Product Support Bulletin 2009-011

DATE:	March 5, 2010		
SUBJECT:	Locking Turntable Cylinder Upgrade Kit – 98410219		
RATING:	DIRECTIVE (Action is required)	ALERT (Potential Problem)	
	X INFORMATION (Action is optional)	PRODUCT IMPROVEM (Enhance Product)	ENT
MACHINE MODEL(S):	CX Hammer		
SERIAL NUMBER(S):	410588-410606		
SUMMARY:	Machines in this serial number range were built with the 28555422 Locking Turntable Cylinder. This cylinder is easily identified by the external lock actuator at the top of the cylinder. See Figure 1 on Page 2. This cylinder is no longer available.		
OPERATIONA IMPACT:	The 28555422 Turntable Cylinder (external lock actuator) has been replaced by the 28555423 Cylinder with an internal lock actuator. The 28555422 cylinder requires Turntable Valve 50078954 and the 28555423 cylinder requires Turntable Valve 50078955 to operate properly. If the 28555422 cylinder is replaced without also replacing the 50078954 Turntable Valve, the locking mechanism will not unlock and the turntable will not function.

Figure 1
Identifying Locking Turntable Cylinders with External and Internal Lock Actuators

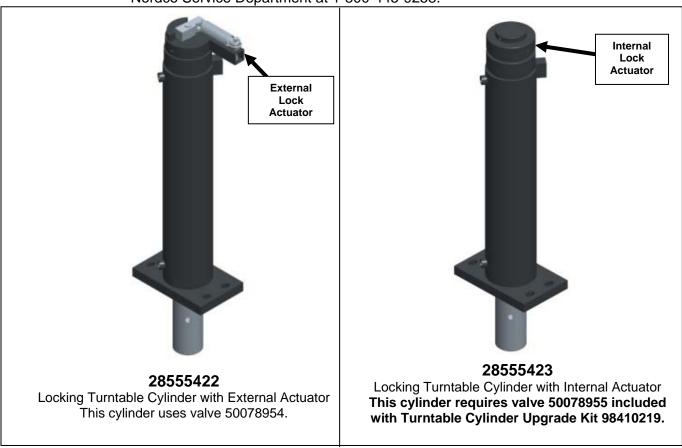
ACTION:	an external lock actuator, the 5 When replacing the 285554: Cylinder Upgrade Kit should Cylinder (internal lock actuator hoses, fittings and hardware ar Valve can be identified by the on Page 2. Note that the pilot	place the 28555422 Locking Turntable Cylin 50078954 Turntable Valve must be replaced 22 Turntable Cylinder, the 98410219 T be ordered. This kit includes a 28555423 had installation instructions. The 50078955 extra port in the valve labeled "DR". See toperated check valve connected to the er must also be removed as shown in Fig.	d as well. Turntable Turntable additiona Turntable Figure 2 cap-end

Figure 2

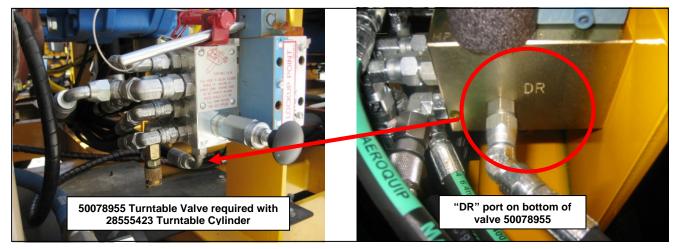
The 50078955 Turntable Valve has a port on the bottom labeled "DR". The 50078954 valve used with the 28555422 Turntable Cylinder does not have this port.

Figure 3

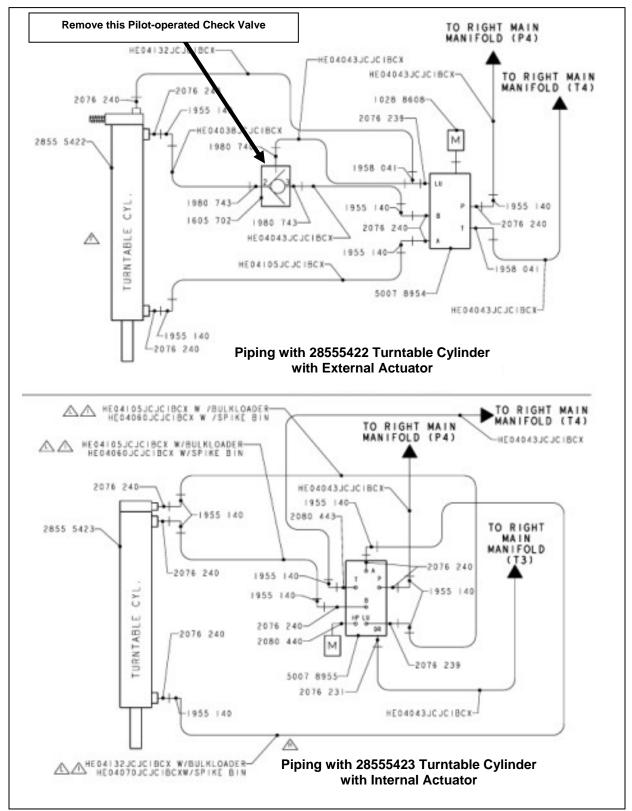
Remove the Pilot-operated Check Valve when replacing the 28555422 Turntable Cylinder with the 28555423 Turntable Cylinder.
